ADDENDUM NO. 6

CLASSROOM ADDITION TO ELVIN HILL ELEMENTARY SCHOOL

Architect Job No. 25-34

January 9, 2026

EXHAUST FAN INSTALLATION DETAIL

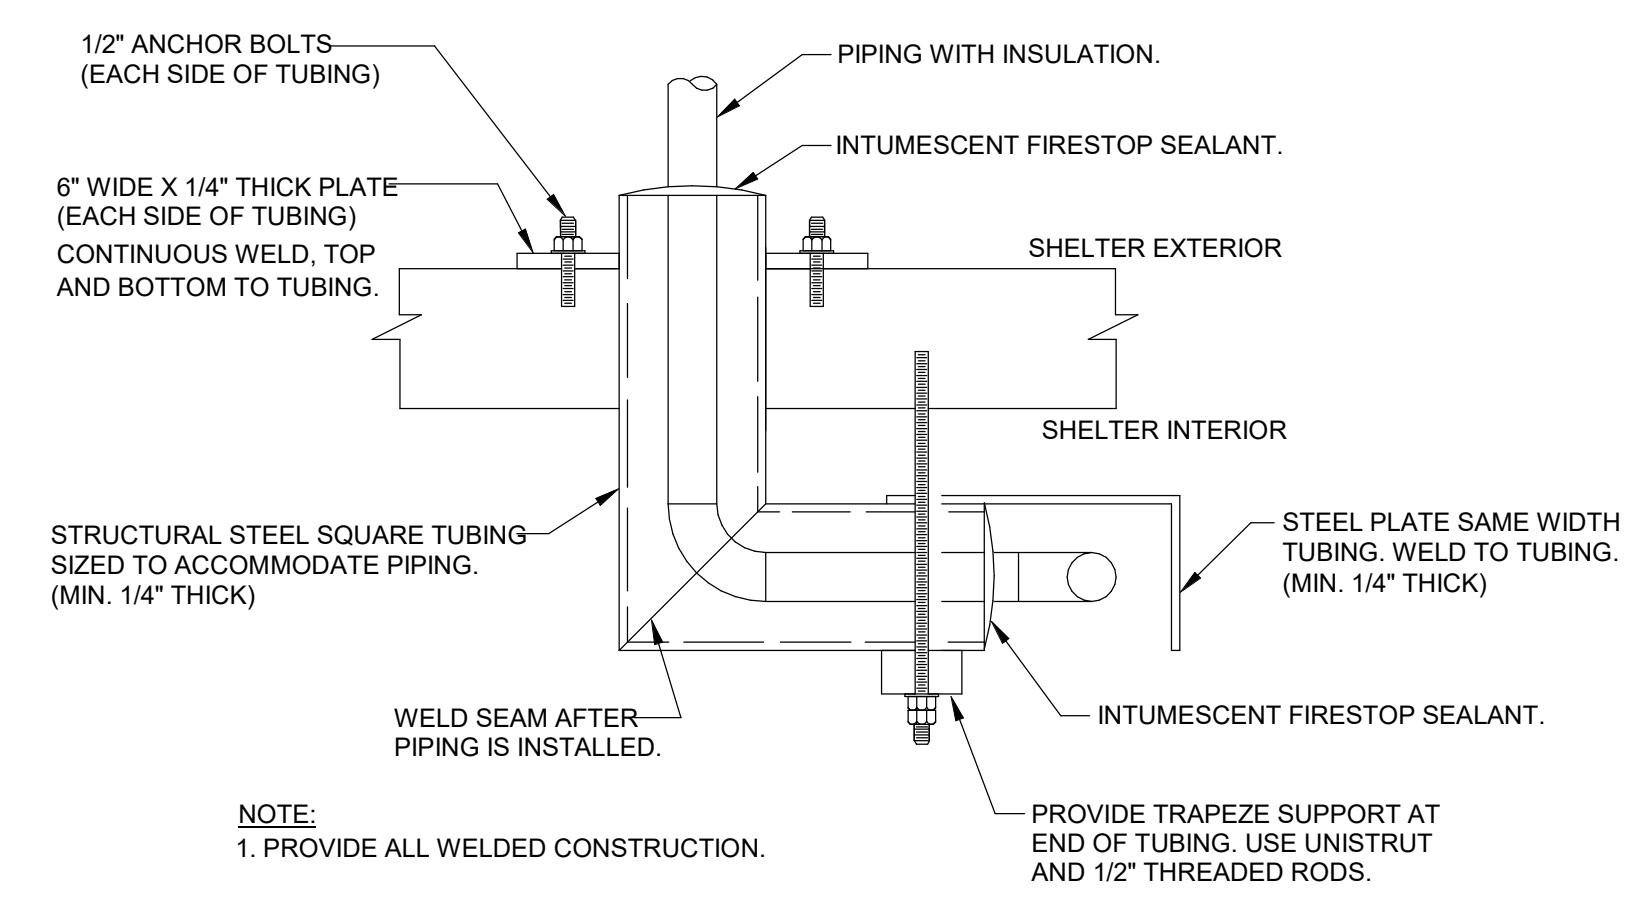
1. **SHEET M0.2 – MECHANICAL SCHEDULES:** Added schedule and notes for exhaust fan EF-2.
2. **SHEET M0.4 – MECHANICAL DETAILS:** Added roof mounted exhaust fan detail.
3. **SHEET M1.1 – MECHANICAL – FLOOR PLAN – BASE BID:** Added ductwork for exhaust fan EF-2 and respective intake duct. Also added control sequence for EF-2.
4. **SHEET M1.2 – MECHANICAL – FLOOR PLAN - ALTERNATE:** Added ductwork for exhaust fan EF-2 and respective intake duct. Also added control sequence for EF-2.
5. **SHEET M1.3 – MECHANICAL – ROOF PLAN:** Added exhaust fan EF-2 and respective intake hood.
6. **SHEET M2.2 – MECHANICAL PIPING – ROOF PLAN – BASE BID:** Added exhaust fan EF-2 and respective intake hood.
7. **SHEET M2.3 – MECHANICAL PIPING – ROOF PLAN - ALTERNATE:** Added exhaust fan EF-2 and respective intake hood.
